# **Safety System Digital Platform - MELTAC - Topical Report**

**TAC No. MF4228  
Issue Date: February 5, 2019**

**PART 2: Request for Additional Information (RAI), including**

**SUBJECT: FINAL PROPRIETARY SAFETY EVALUATION FOR "SAFETY SYSTEM  
DIGITAL PLATFORM – MELTAC" (CAC NO. MF4228; EPID L-2014-TOP-0006)**

Figure 2 Reliability Model of a Redundant Parallel Controller

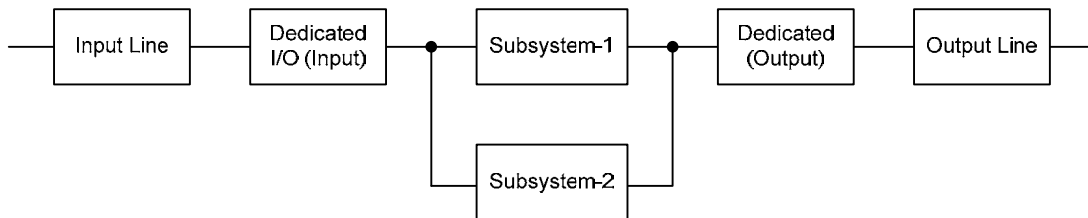
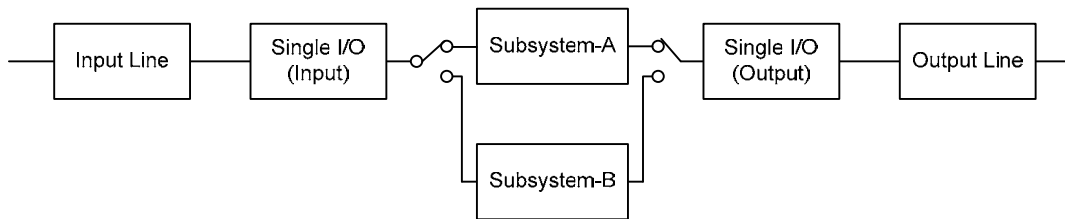
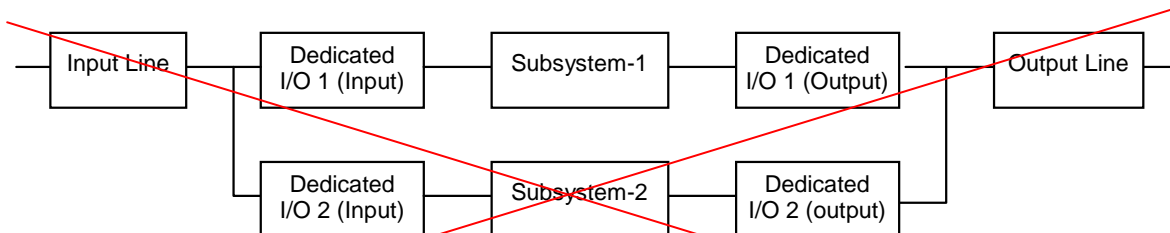
Among these configurations, the configuration that can satisfy the plant specific reliability requirements is applied, with consideration of both actuation assurance and spurious actuation prevention. The actual reliability calculations are in plant specific documentation. The reliability models shown in Section 7.2 are intended to only show the reliability analysis method for each of the three basic controller configurations. The reliability models of these configurations are shown in Figure 1, Figure 2 and Figure 3, respectively.

A comparison of the three controller subsystem configurations is described below. This comparison excludes the reliability of the single I/O modules, which is common to each configuration.

**Figure 7.2-2 Reliability Model of a Redundant Parallel**

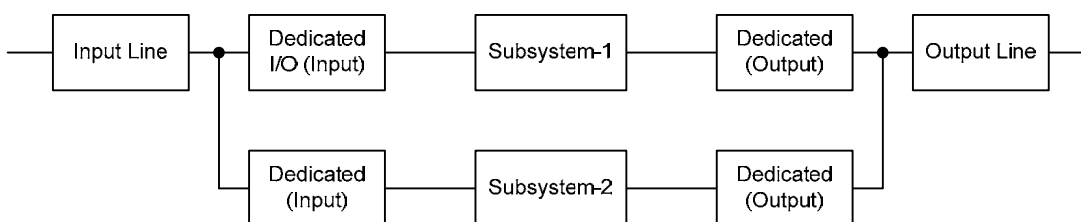
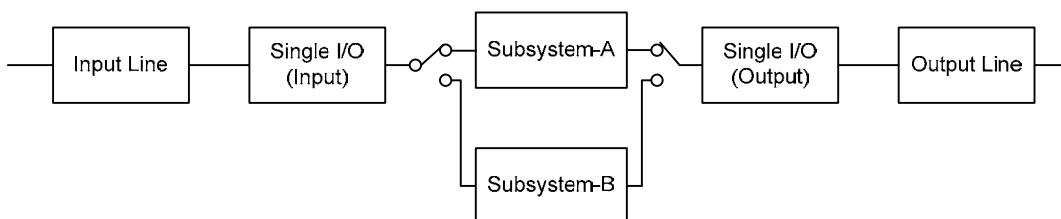
The reliability models of the single controller, redundant parallel and redundant standby controller are shown in Figure 7.2-1, Figure 7.2-2 and Figure 7.2-3 respectively.

A comparison of the three controller subsystem configurations is described below.

**Figure 7.2-4 Fault Tree for Spurious Actuation of Single Controller**

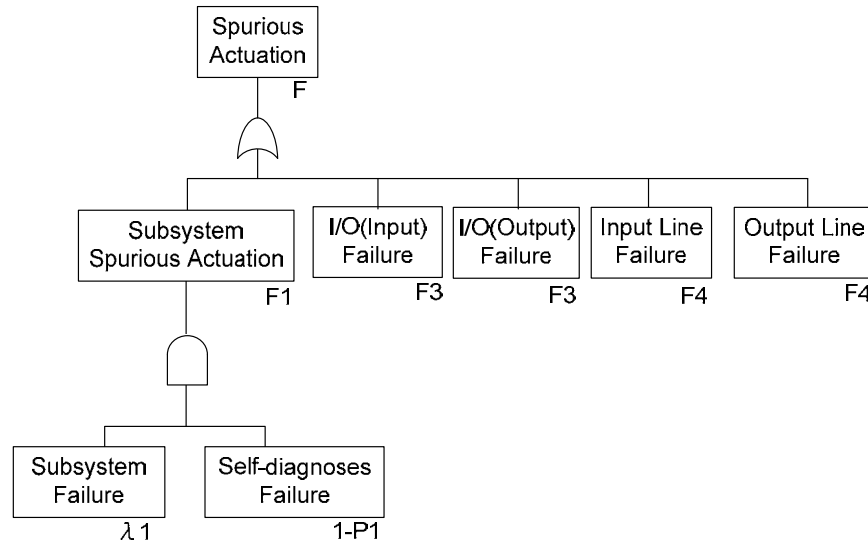
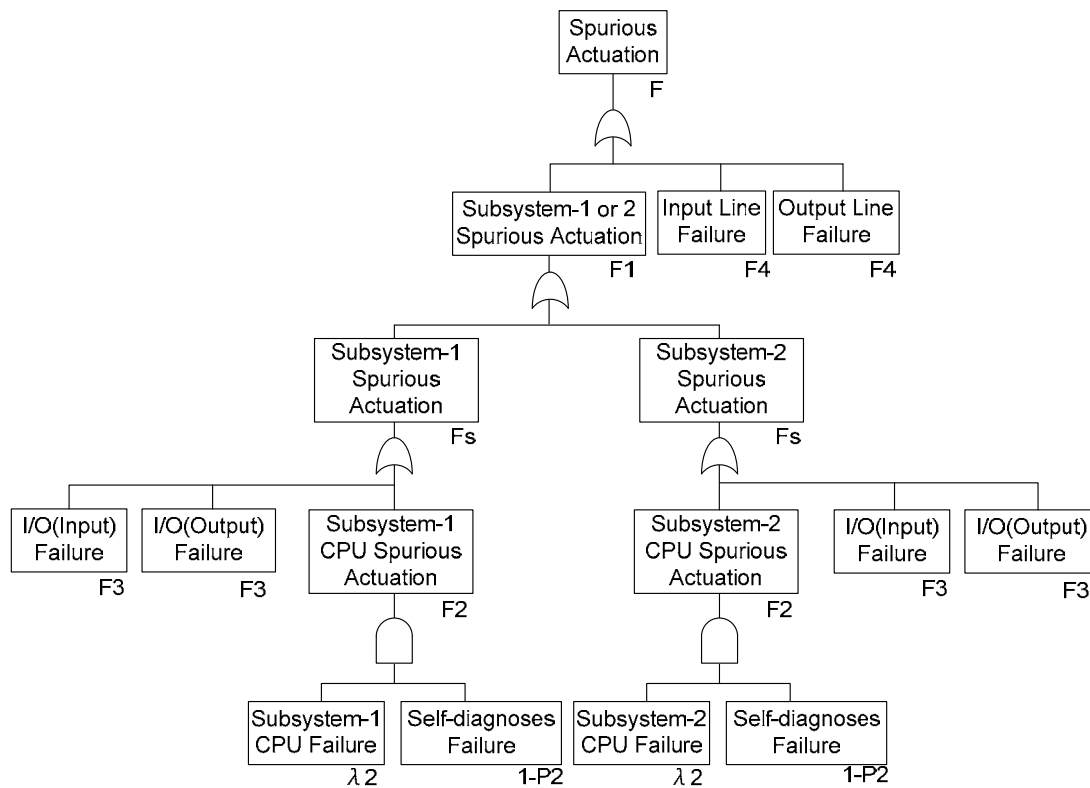
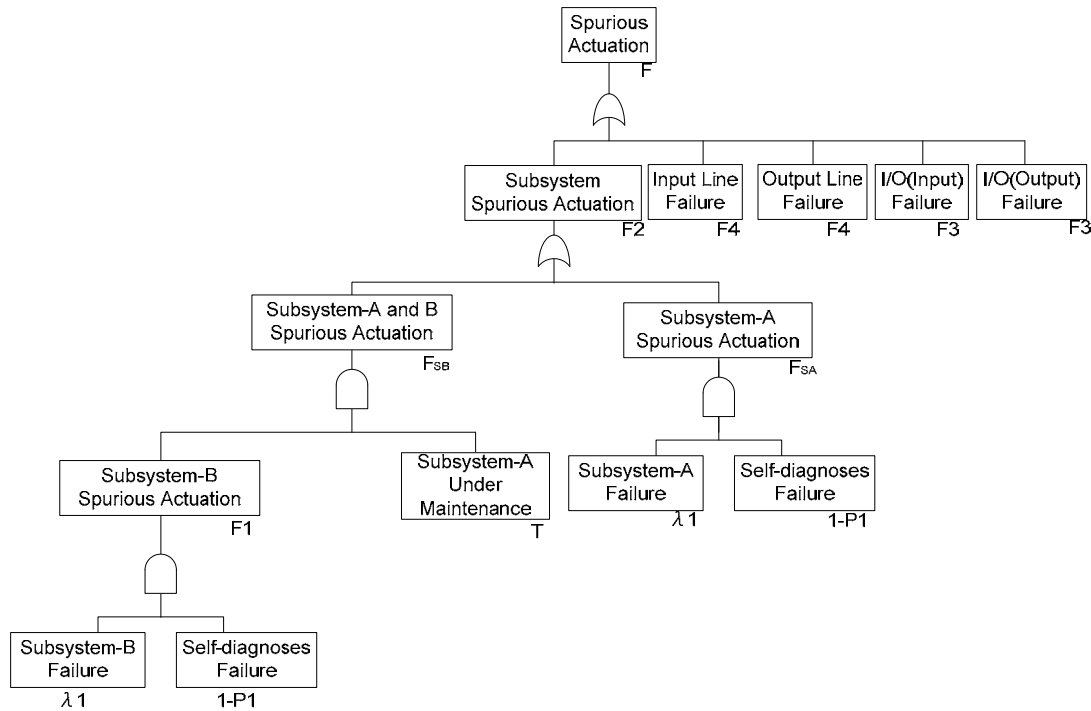
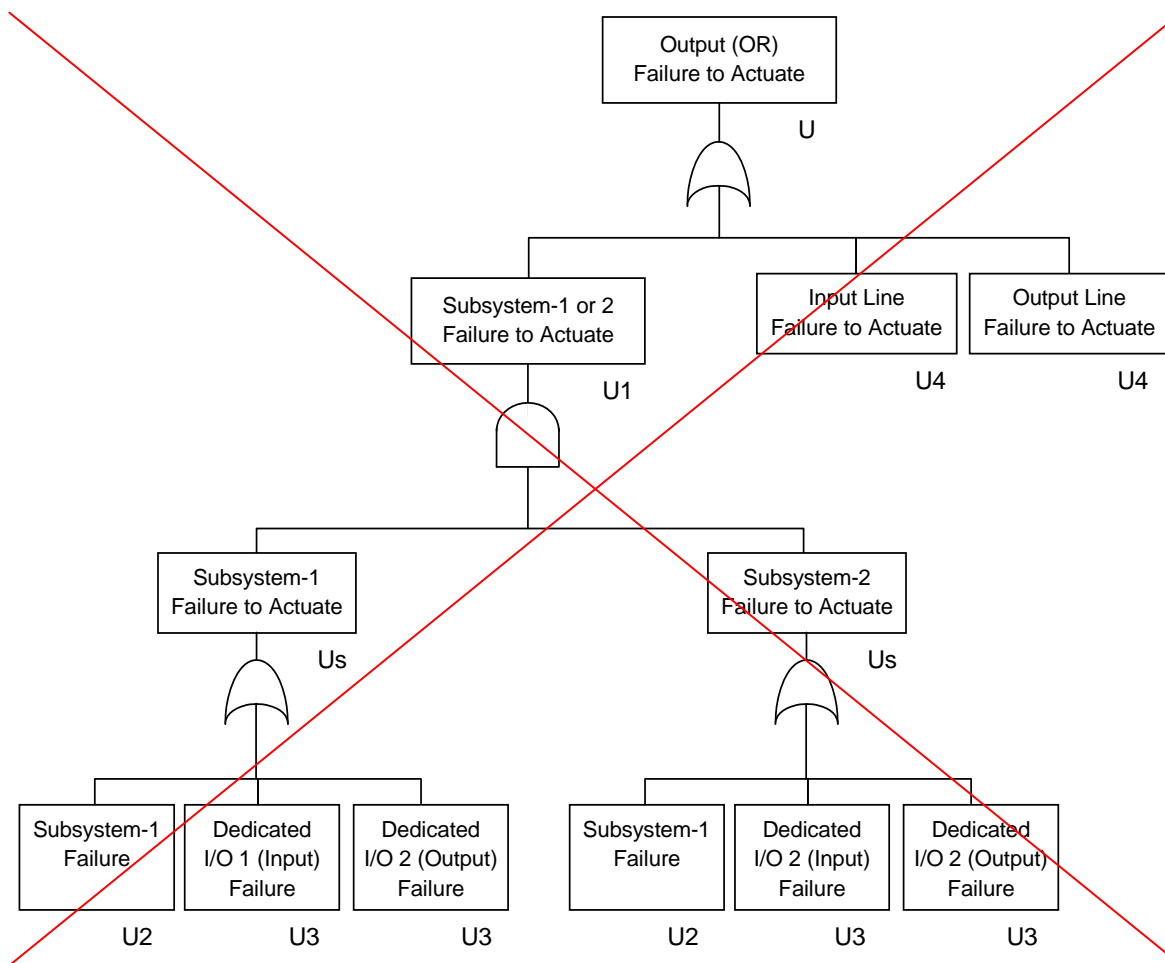
The Figure 7.2-4, Figure 7.2-5, and Figure 7.2-6 show the FTA for spurious actuation of single controller, redundant standby and redundant parallel respectively.

Regarding the cause of spurious actuation of the single controller, the failure rate is described below.

Failure rate  $F_i$  ( $i = 1, 2, 3 \dots$ ) causes spurious action of each module or subsystem and is defined below.

**Figure 7.2-7 Fault Tree for Failure to Actuate of Single controller**

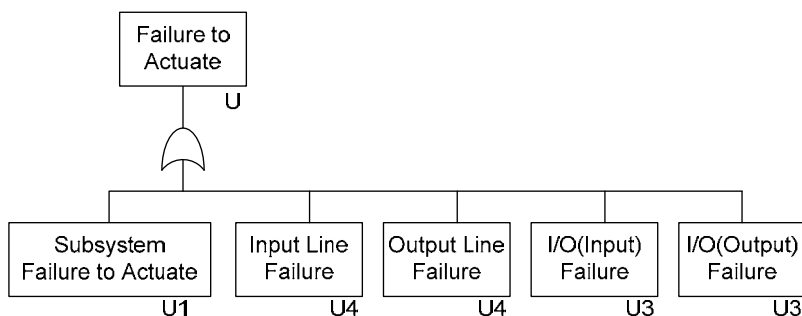
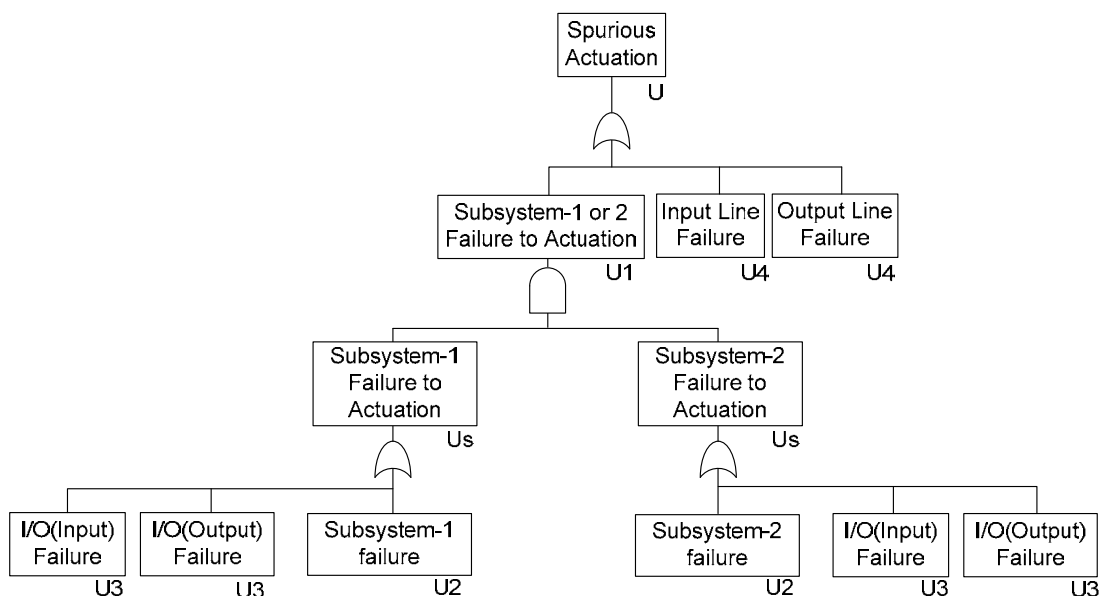
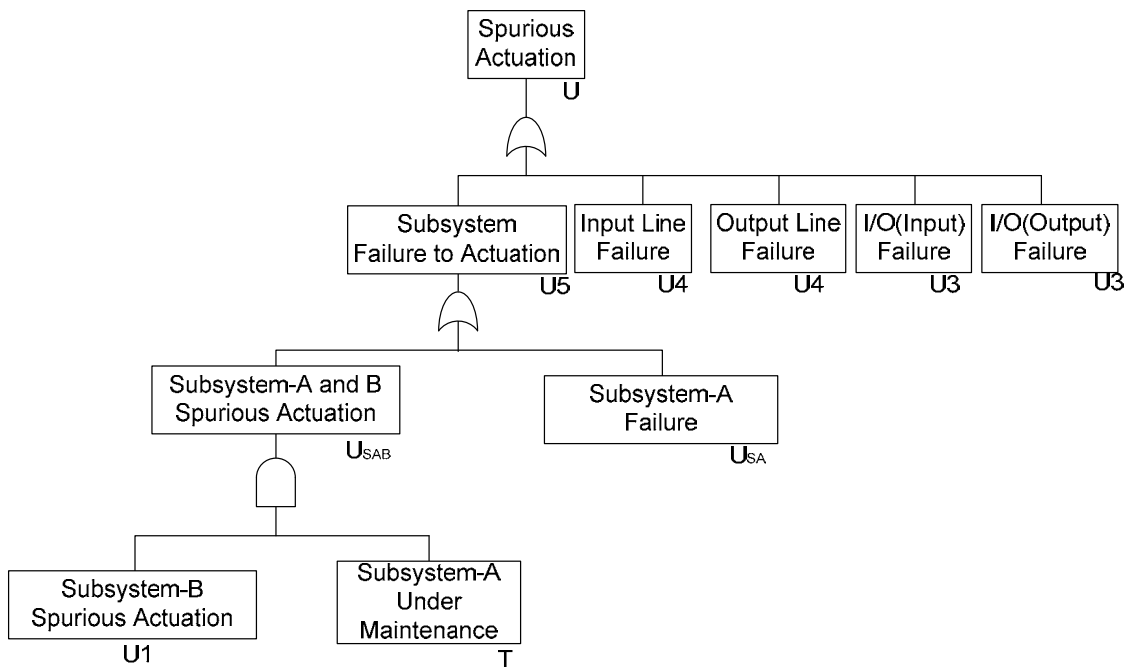
The Figure 7.2-7, Figure 7.2-8, and Figure 7.2-9 show the FTA for failure to actuate of single controller, redundant standby and redundant parallel respectively.

The failure rate of the Status Display and Switch Module is not considered to this analysis because of the same reason of analysis for spurious actuation.

Ti and Mean Time To Repair (MTTR) are unique to each application.

Figure 1 Failure detection capability for maintenance bypass

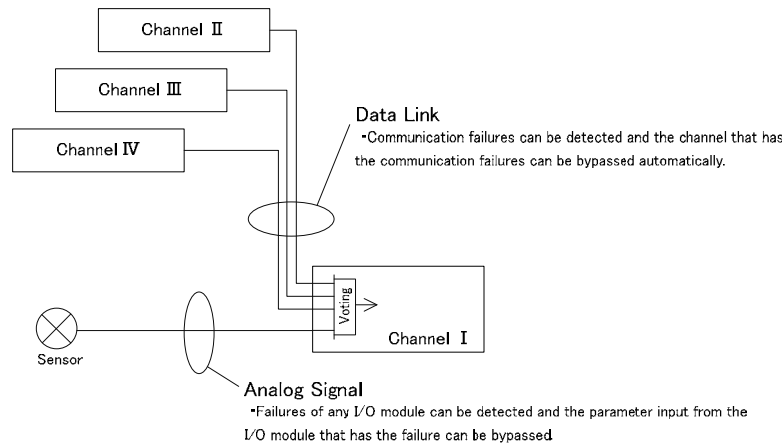
Figure 1 shows the failure detection capability of the MELTAC platform for automatic maintenance bypass in a typical system configuration. Any automatic maintenance bypass is subject to any application interlocks that may prohibit the automatic maintenance bypass if a channel from another division is already bypassed.
